678.22 VEHICLE LOOP DETECTOR

TRAFFIC LOOP LAYOUT SHEET #2	PROJECT NAME: WALLINGFORD - RUTLAND TOWN	
	PROJECT NUMBER: AC NH 2207(I)S	
	FILE NAME: p99bl66.dgn	PLOT DATE: 12-MAR-2007 11:30
PROJECT LEADER: D.E.G.	DRAWN BY: C.A.K.	
DESIGNED BY: D.W.E.	CHECKED BY: D.E.G.	
		SHEET 41 OF 95

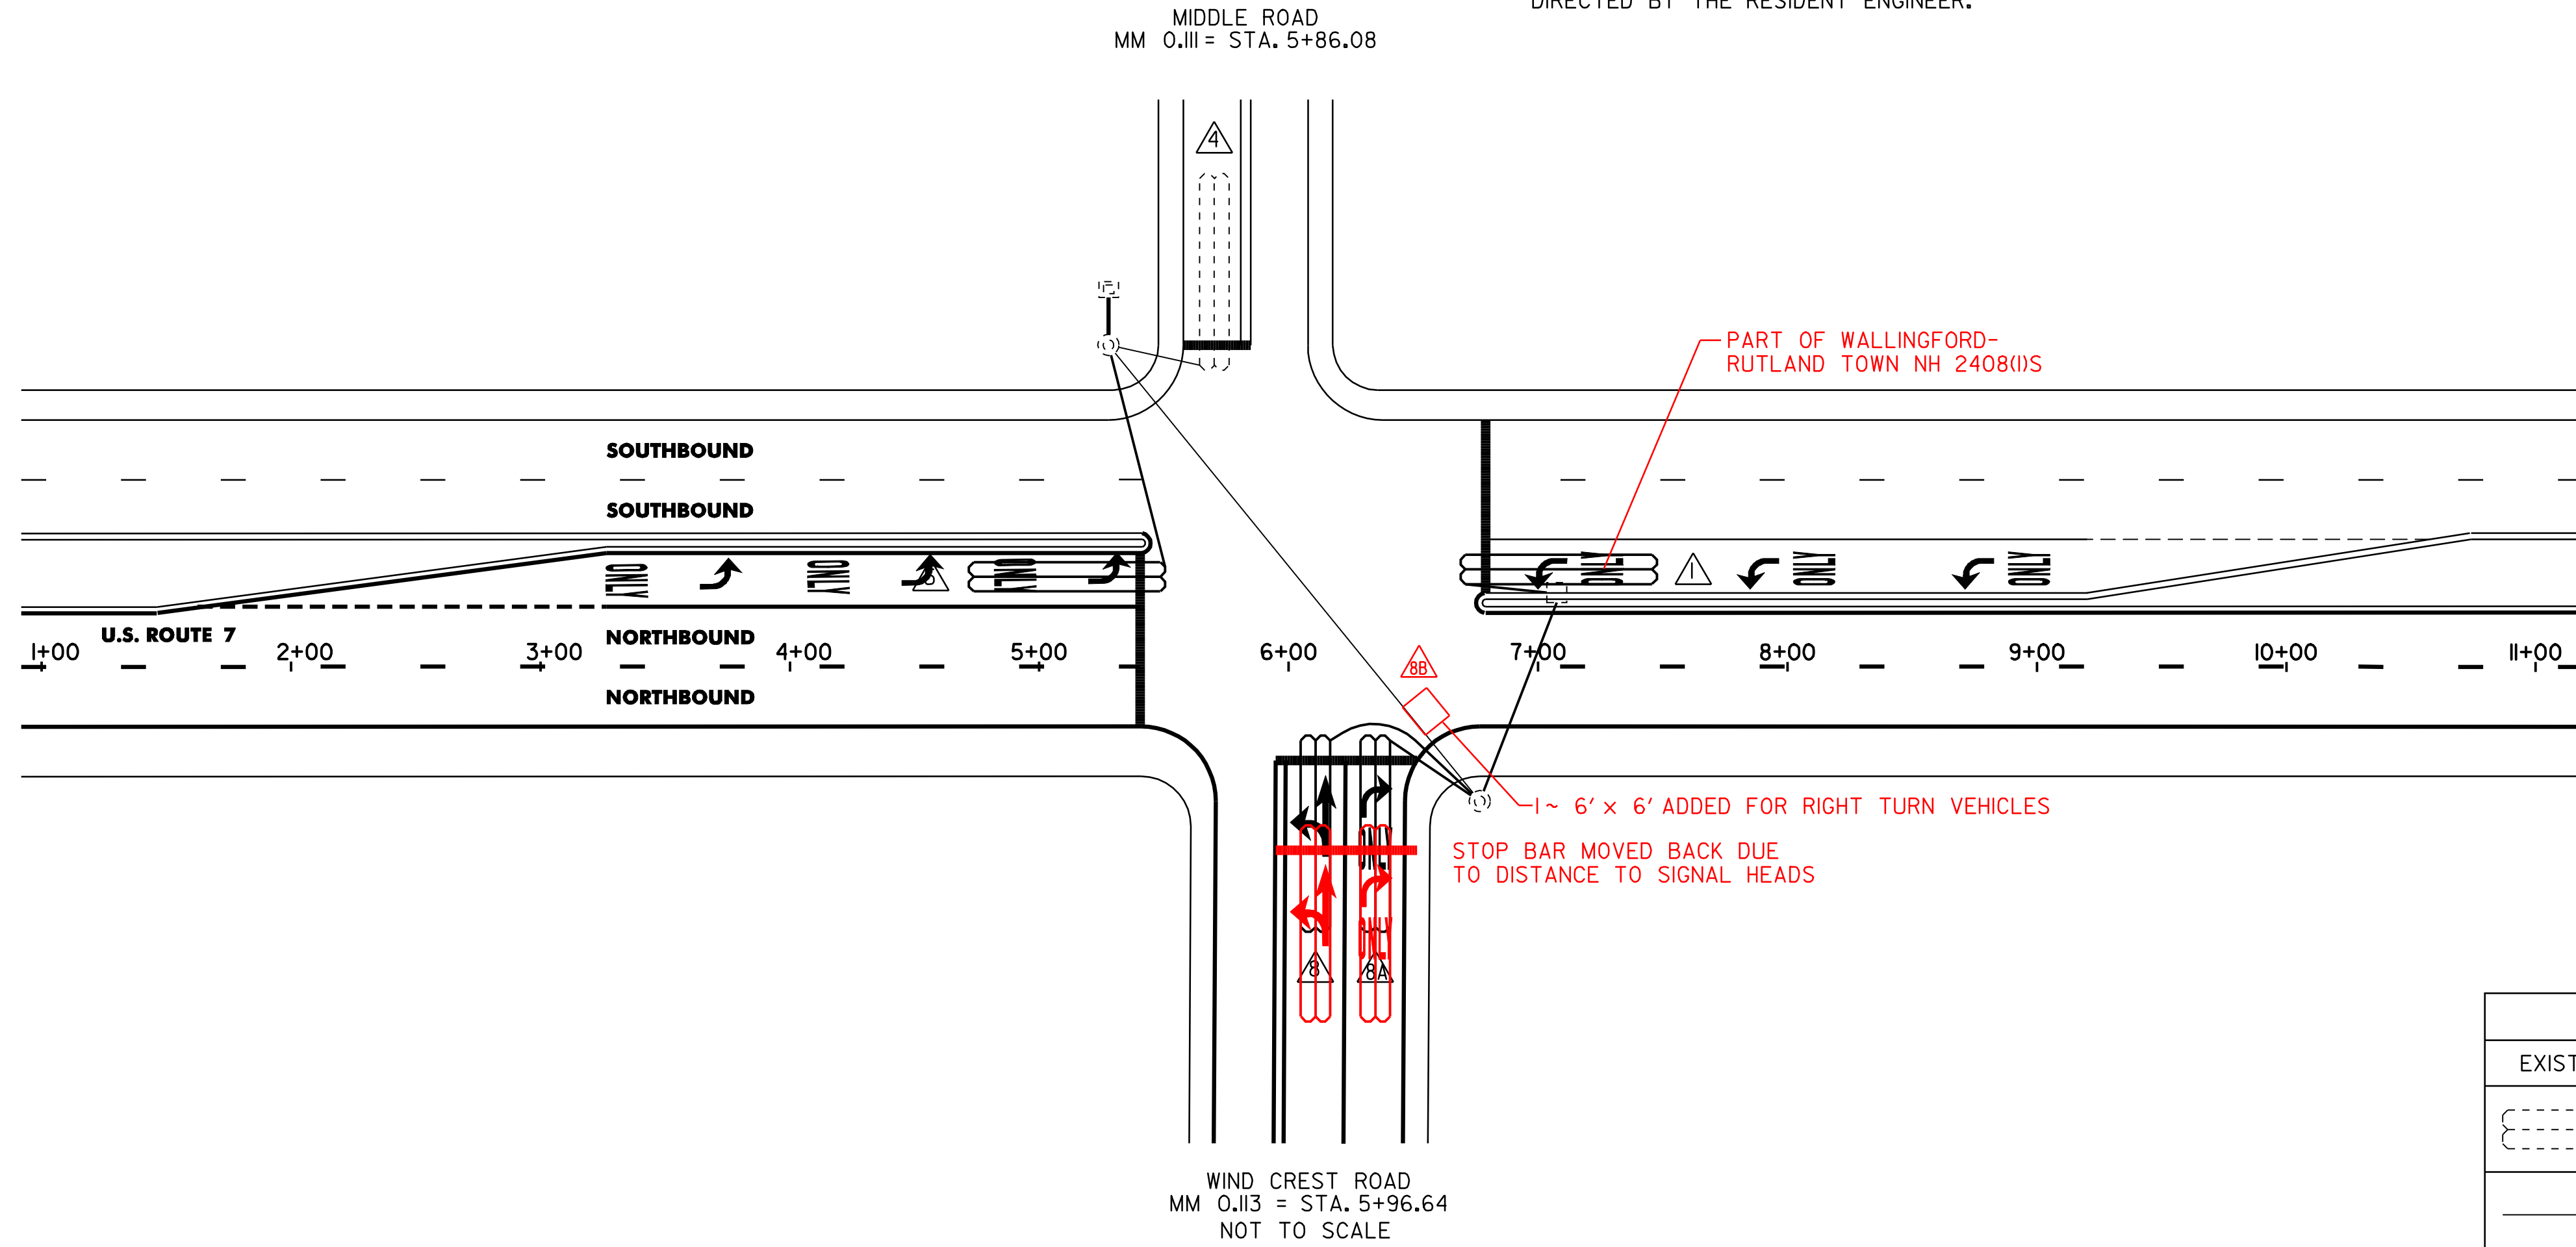
~~LOOP 1 - 174 FT~~
~~LOOP 5 - 160 FT~~ 178 FT
~~LOOP 8 - 162 FT~~ 162.5 FT
~~LOOP 8A - 150 FT~~ 150.5 FT
~~LOOP 8B - 33 FT~~
